NEDO-24154-A
78NED290R1
CLASS I
AUGUST 1986

LICENSING TOPICAL REPORT

QUALIFICATION OF THE ONE-DIMENSIONAL CORE TRANSIENT MODEL FOR BOILING WATER REACTORS VOLUME 1

Docket No. 50-271 Official Exhibit No. Entergy 26

Figure 4-14. Motor-Generator Flow Control Block Diagram

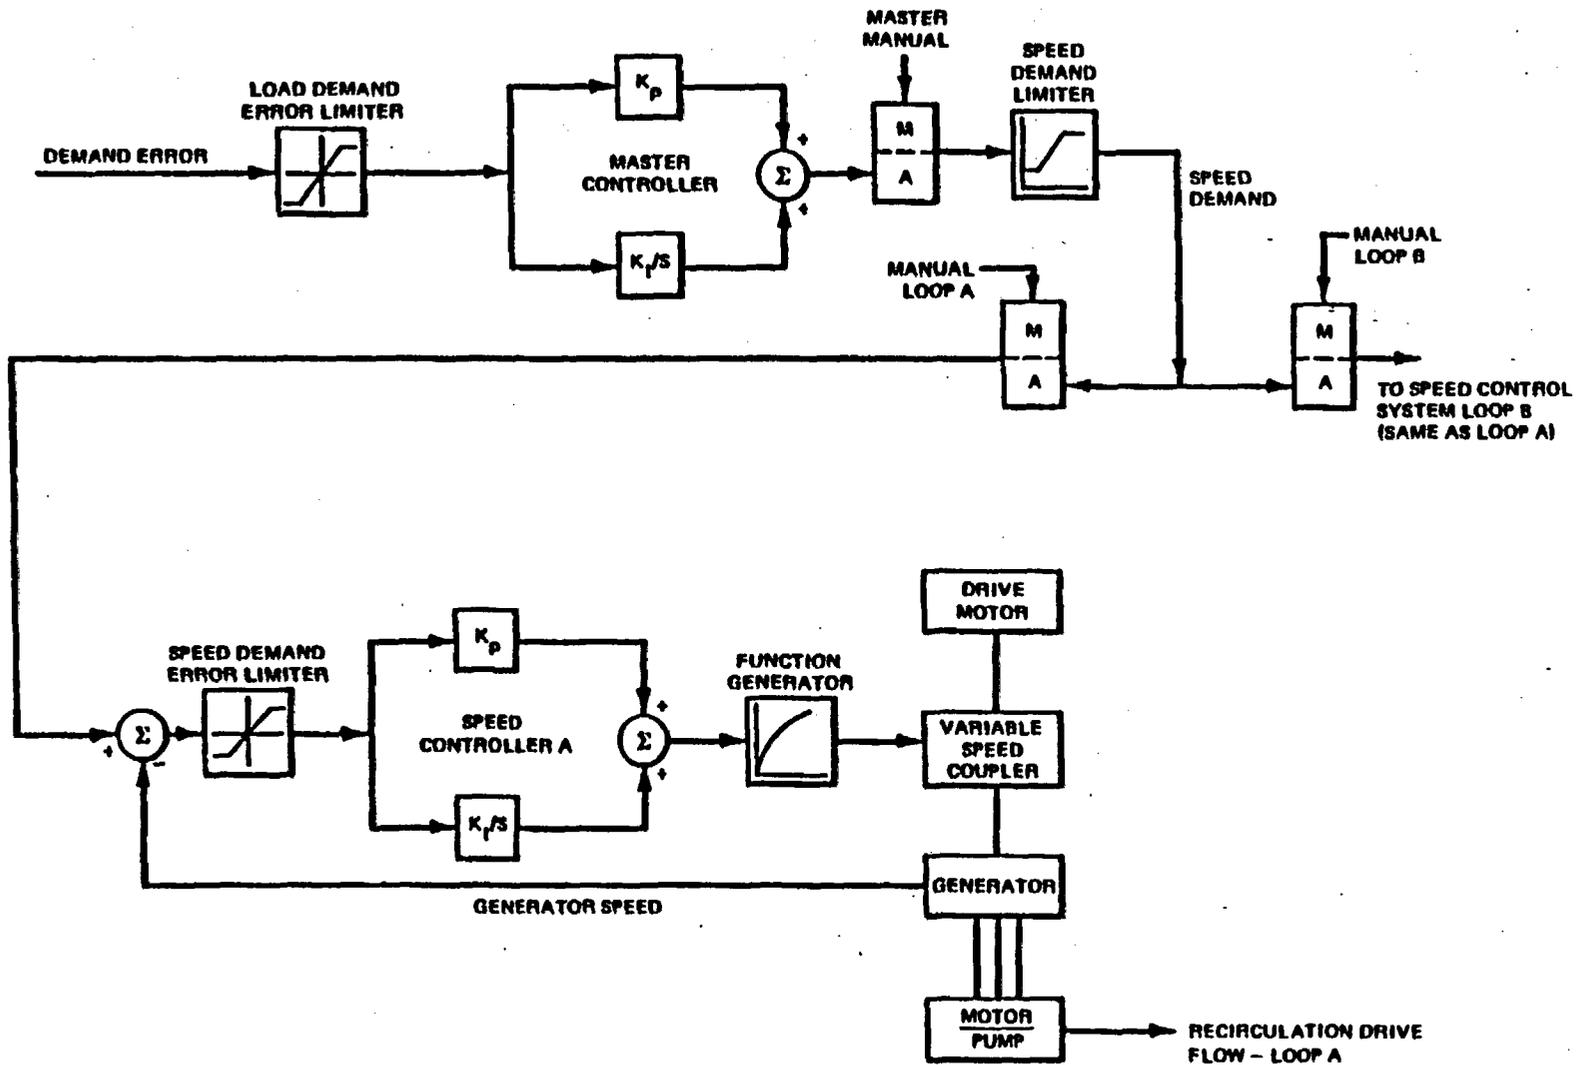
Figure 4-14 provides a block diagram of the motor-generator flow control system. Additional description of the control system is required in order for the staff to complete its review of the block diagram. In this regard, provide the following information:

Figure 4-15. Feedwater Control

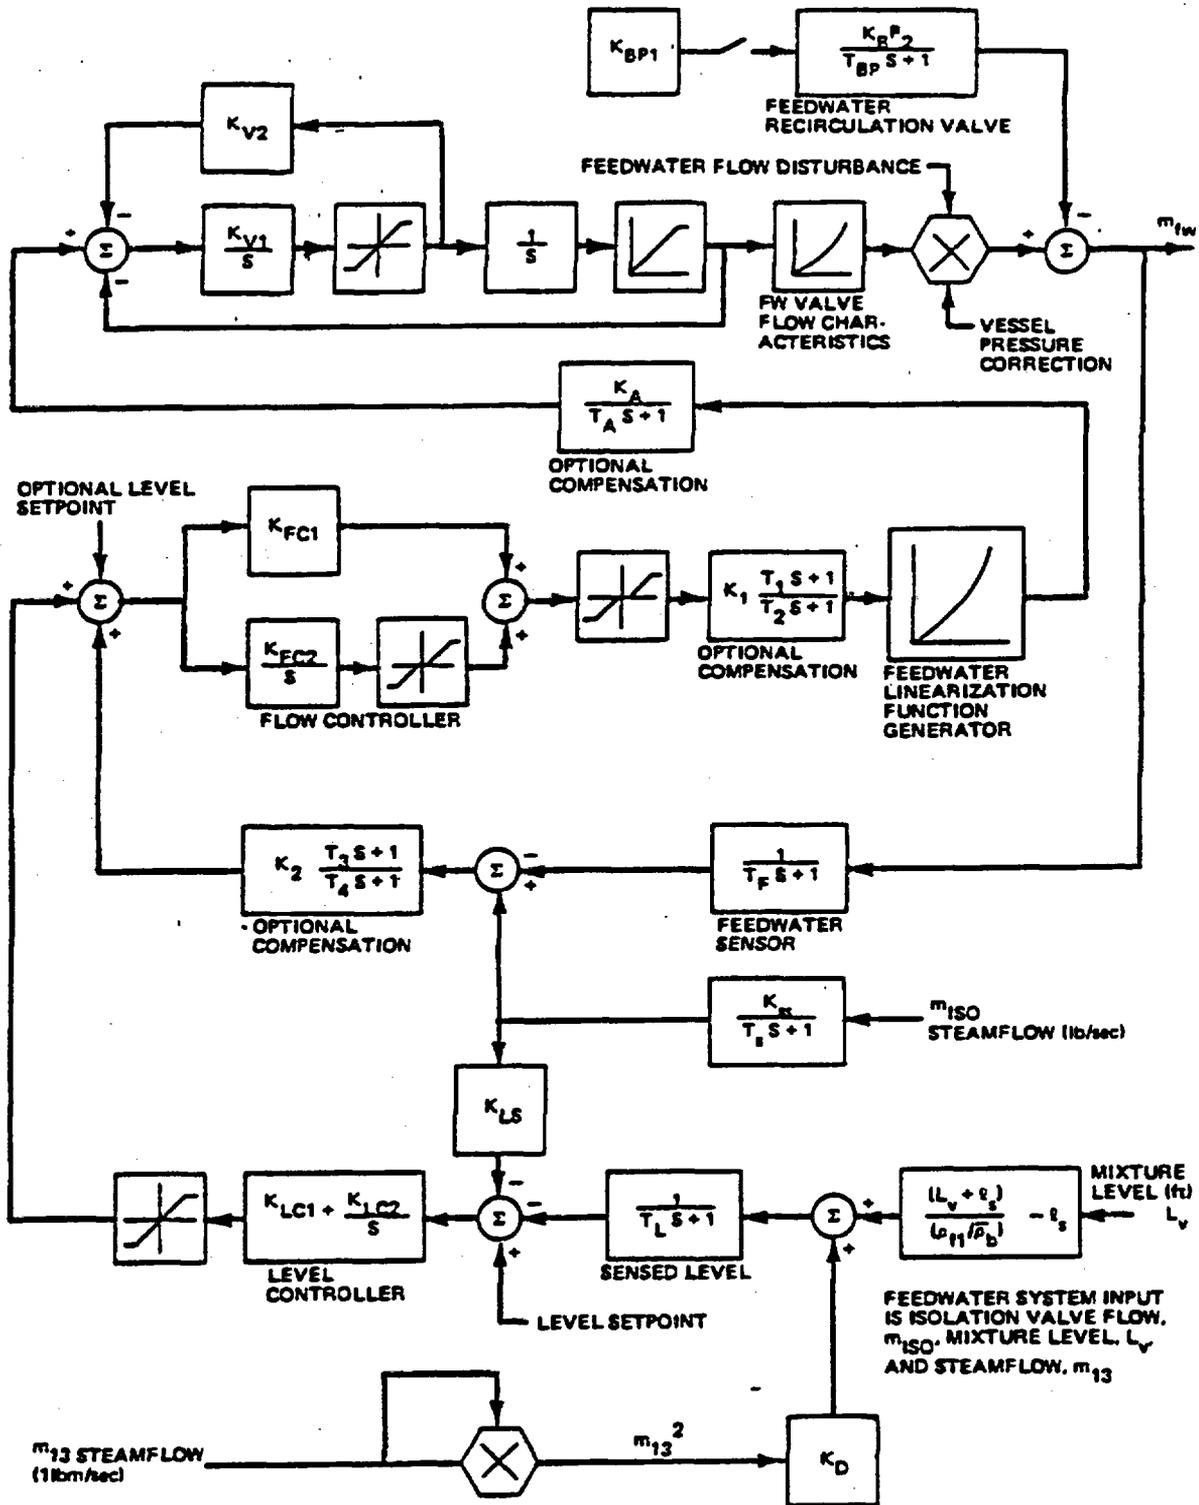
Figure 4-15 provides a block diagram of the feedwater control. Additional description of the control system is required to complete review of the block diagram. In this regard, provide the following information:

Figure 4-16. Pressure Regulator Block Diagram

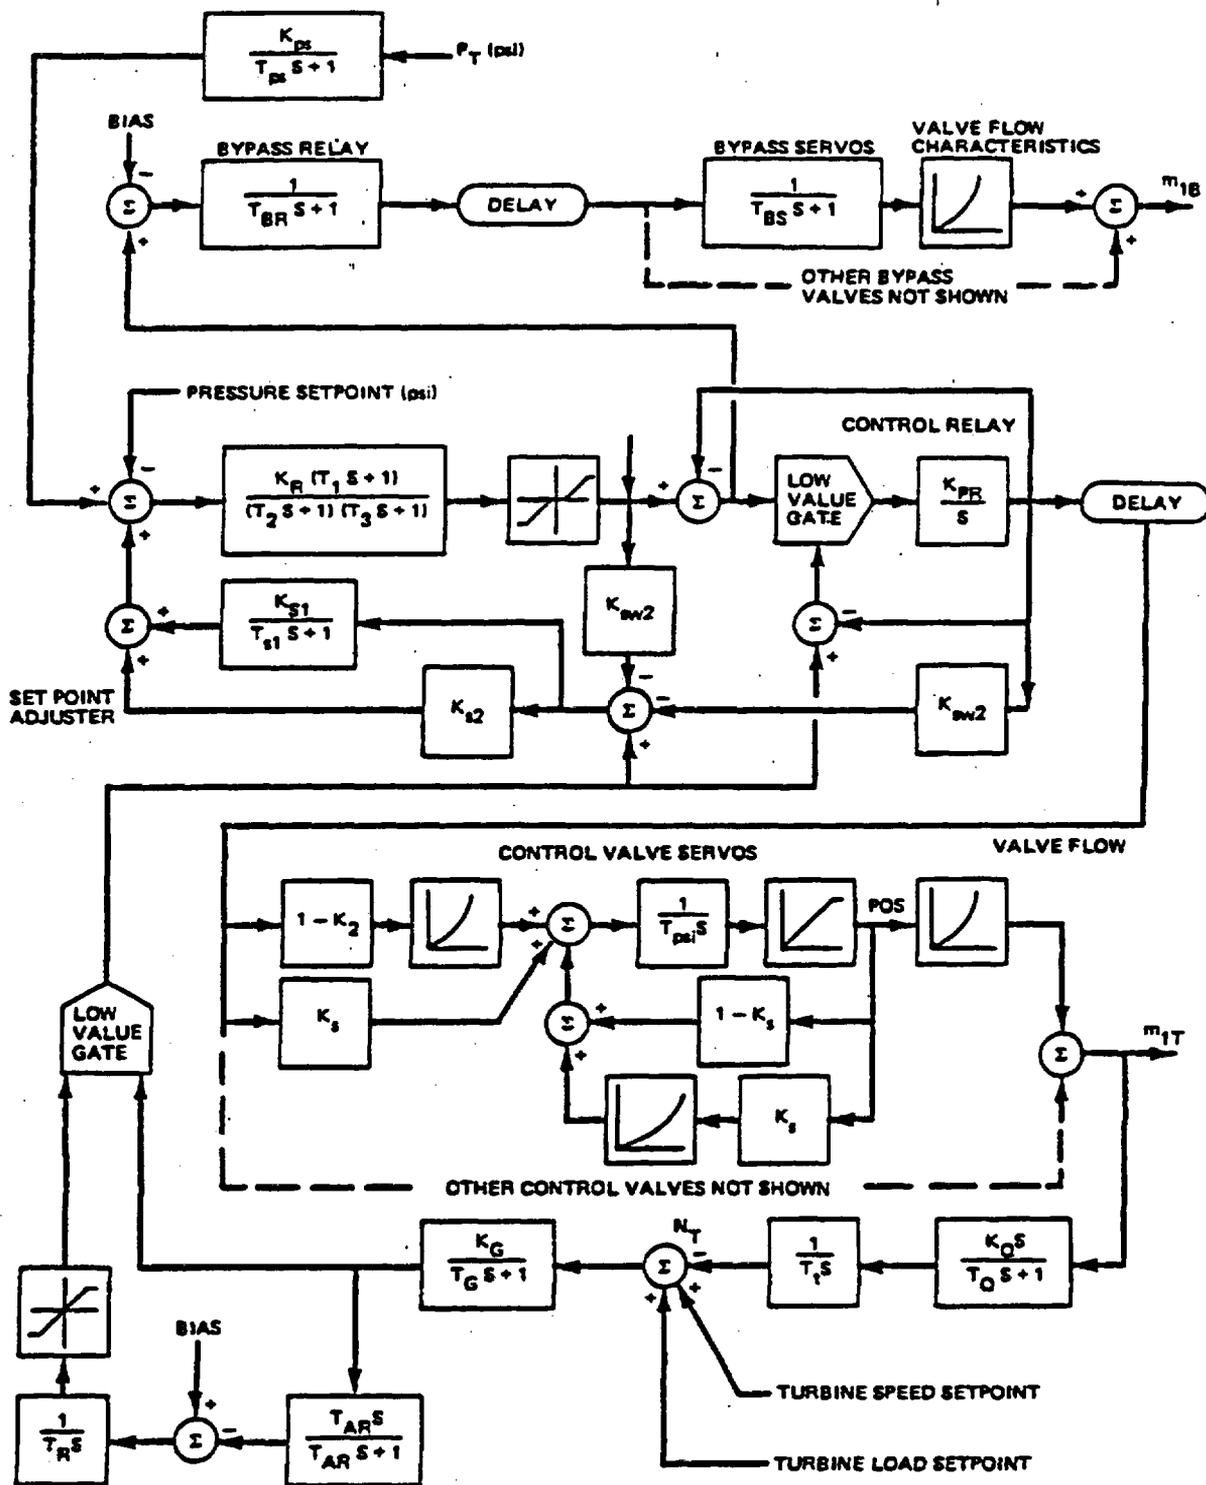
Figure 4-16 provides a block diagram of the pressure regulator system. Additional description of the control system is required to complete review of the block diagram. In this regard, provide the following:

Figure 4-16 represents a model of a typical BWR pressure regulation system for main steam turbine equipped with Mechanical Hydraulic Control (MHC). Turbine inlet pressure is regulated by a closed-loop feedback control system, through manipulation of the turbine admission valves or steam bypass valves, utilizing the sensed inlet pressure as the feedback signal. For normal operation, the turbine admission valves are designed to regulate steam pressure; however, whenever the steamflow demand exceeds that which can be passed by the turbine admission valves, the pressure control system demands the excess steamflow to be sent to the main condenser through the steam bypass valves. In addition, when the reactor is operating in the automatic load following mode, provisions are made within the pressure control system to allow temporary adjustments to the desired pressure setpoint by means of the setpoint adjuster to permit a faster steam flow response to changes in load demand, thereby utilizing a part of the stored energy capacity in the vessel. The pressure control system is designed to achieve the following design objectives:

The pressure regulator shown in Figure 4-16 is a proportional plus lag-lead compensation. The proportional gain and lag-lead time constants are determined based upon transient simulations of the BWR to achieve stable pressure control and to achieve the design objectives stated above. The nonlinearities shown on Figure 4-16 are representations of inherent hardware characteristics (such as control value flow vs. value position), electronic functions generators to linearize control value flow to control value demand, hardware limiters and deadband.

Figure 18-1. OLYN Pressure Nodal Diagram

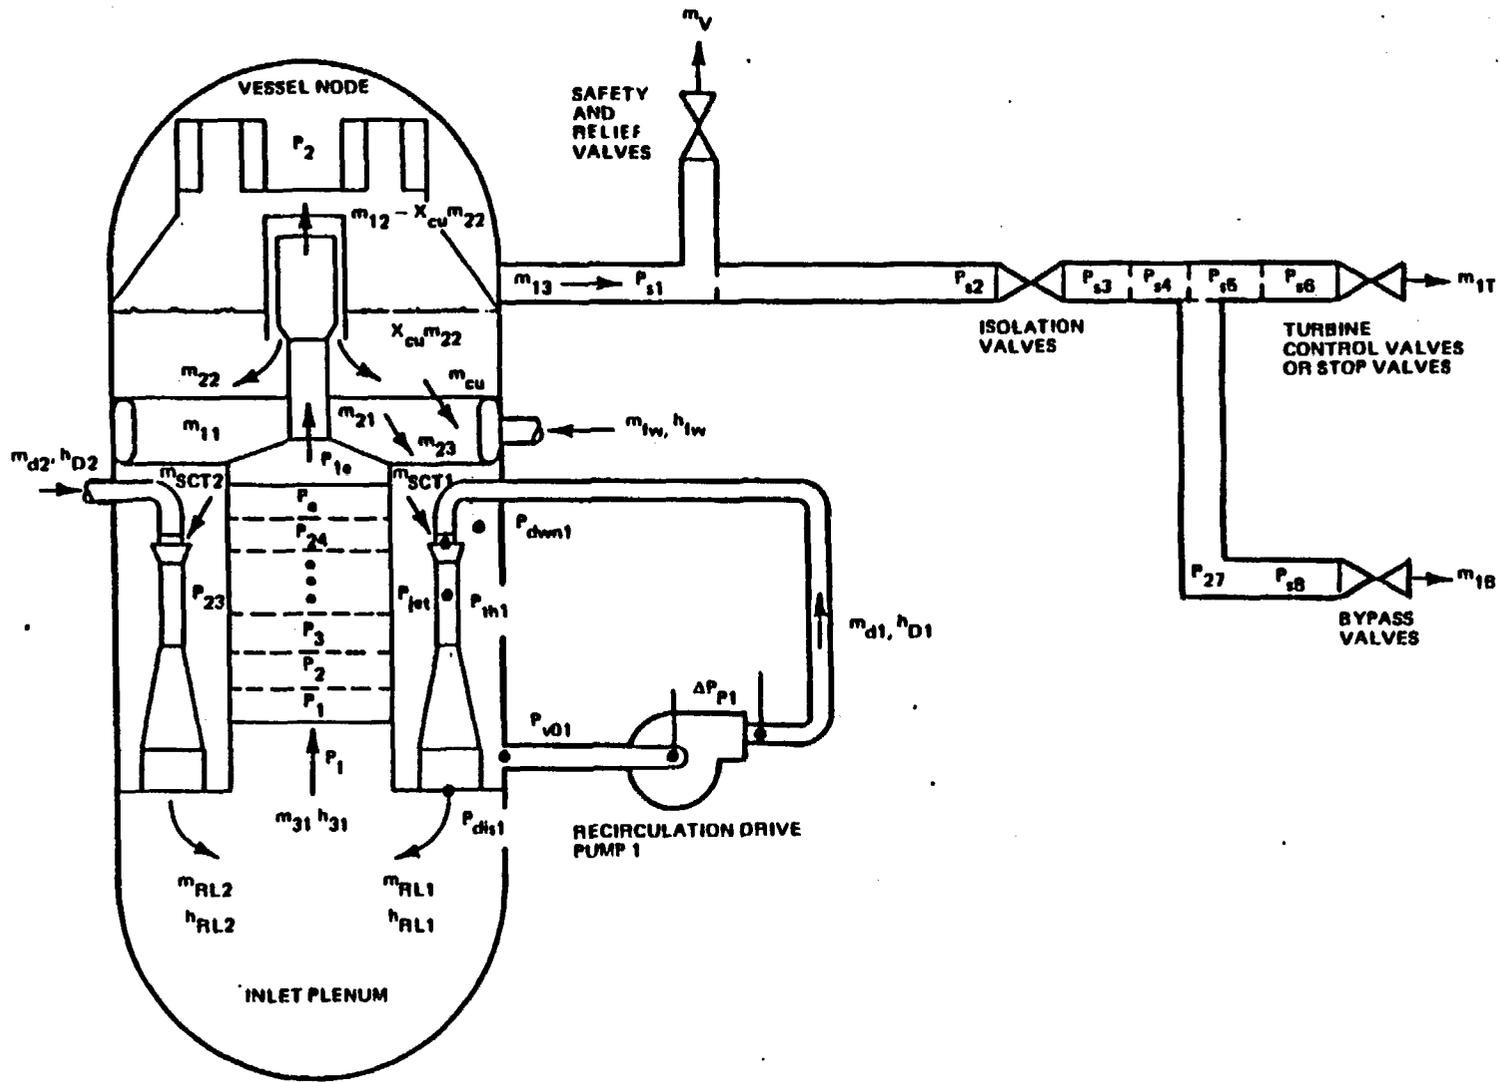
Figure 4-1 is insufficient to derive Equations 4-35 through 4-40. Draw the proper figures in detail, indicating the meaning of all symbols on the figures.

The attached nodalization diagram (Figure 18-1) indicates the pressure nodes in the ODYN model. Note that the core is nodalized axially as is the steamline.
